DESIGN REVIEW BOARD – URBAN DESIGN PANEL

February 3, 2022

**Planning Staff Report to
Design Review Board - Urban
January 21, 2022**
for the February 3, 2022 Public Hearing

Docket Number:	21-945
Applicant:	David Thompson, Architect
Property Owner:	Kirk Crawford, Windsor Aughtry
Property Location:	40 W. Broad Street
Tax Map Number:	0059000400206, 00590004002070
Acreage:	.36, .22
Zoning:	C-4, Central Business District, Halprin District, Court Square District
Proposal:	Construction of new structure and amenities in courtyard, exterior modifications to storefront of existing building
Staff Recommendation:	Approve with Conditions

1
A205 VIEW FROM MAIN STREET

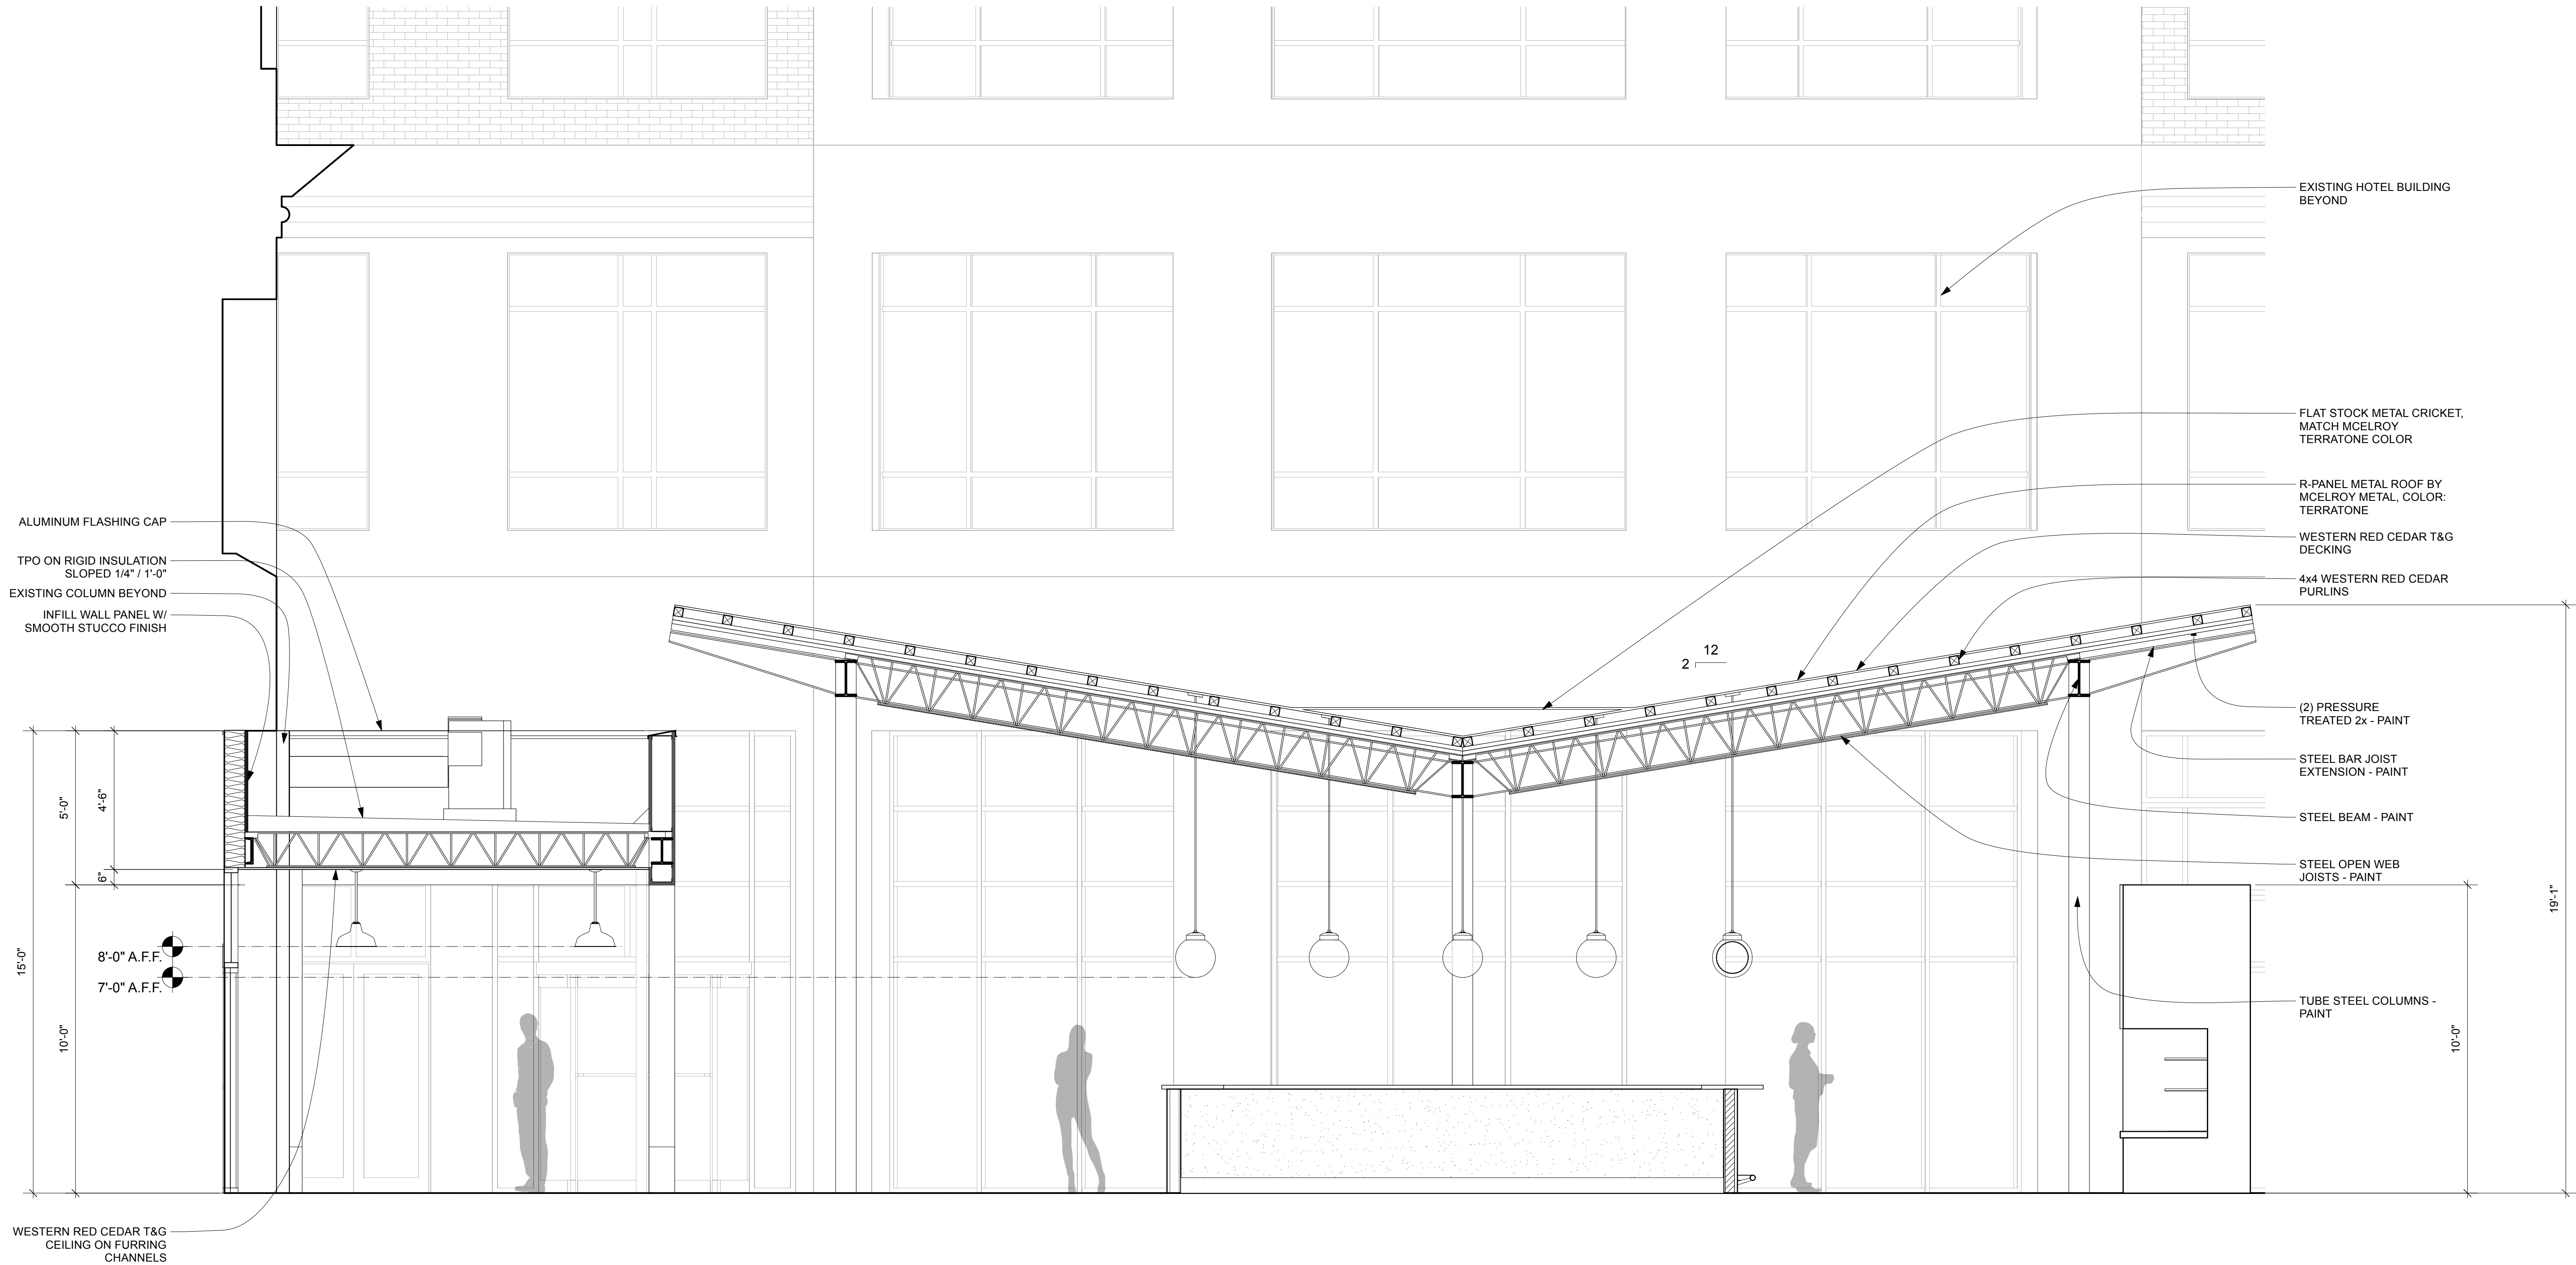
Staff finds that the revised roofing material selection, paired with the additional rendering of the view from Main Street satisfy previous concerns regarding visibility of the roof from the public realm.

SITE PLAN

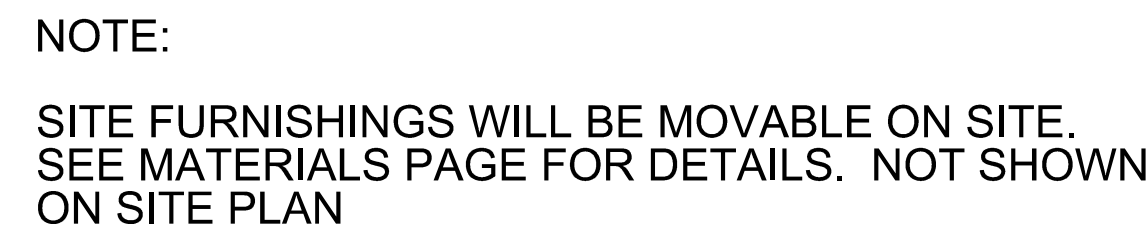
Staff notes one discrepancy that appears to exist between the application statement and the drawings. The applicant states that the plaza will be separated from the street with aluminum panels, but the site plan and renderings show planters as a means of separation. Staff concurs with the use of planters but does not recommend aluminum panel screening. The use of aluminum panels to separate the space should be avoided as it would isolate the plaza from the public and discourage use. Staff finds the proposed planters, indicated on the site plan, as a solution for separation that meets the Downtown Design Guidelines, however, staff recommends that the 3-foot-tall evergreen hedge shall be reconsidered and replaced with softer plant materials to provide a more inviting environment.

- 2. The applicant shall provide planters with appropriate plantings to screen between the plaza and Augusta Street and not use aluminum panels.**
- 3. Applicant shall work with zoning staff to ensure that any outdoor performances on the proposed stage are properly permitted, adhere to the noise ordinance, and do not operate outside of permitted hours.**

Figure 3: Previous unapproved building permit plans showing the requested elevation. The existing door would be bricked in, and the entrance would be relocated where the dock doors used to be. Note the new deck and its elevation change where the existing door is.

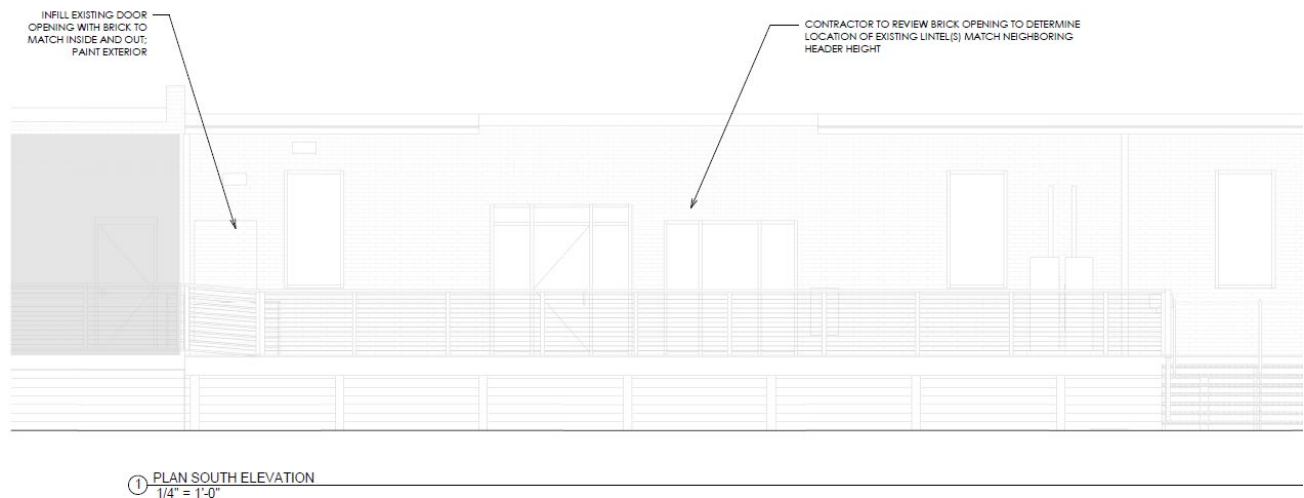
Staff finds the request to remove and brick in the doorway would alter the character of the warehouse façade and conflict with the Unity Park Neighborhood District Code intent and guidelines. Staff recommends that the door be replaced with a storefront window system, as approved within the permits, in order to maintain the existing character of that opening.
